RE: Robust Design Review II of 1149-1151 Walnut Street, Newton Highlands, MA

Robust Design Review Elevation Study II by Developmental Resources, Inc., March 7, 2021

Alternative #2: Walnut Street Elevation with BOX-BOW Windows and No Exterior Balconies

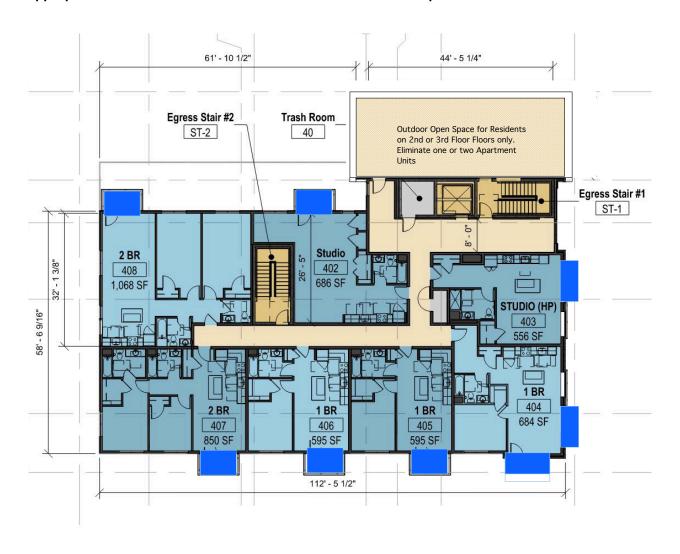
If you remove one or two units, there are still 23 or 24 units and avoid issues with the abutter. The parking ratio is near 1:1. The plans do not correctly show the projected bow windows shown on the front elevation. The projected balconies should be eliminated. "French" balconies flush with the building would be more appropriate to a US Historic District and avoid privacy issues. Another alternative is to convert all of the bow windows and projected balconies into box-bow windows per plan and elevations below. The apartment units will be larger with a better layout. The typical floor plan can be redesigned with larger apartments and keep between 23 to 25 units. I BR and 2 BR apartments are more appropriate for Newton Seniors looking to stay in Newton.

New buildings within an US Historical District like Newton Highlands should match size, proportion, materials and colors but appear to be new. Box-Bow Windows would be more appropriate. The exterior balconies should be eliminated and space added as Box-Bow Windows.
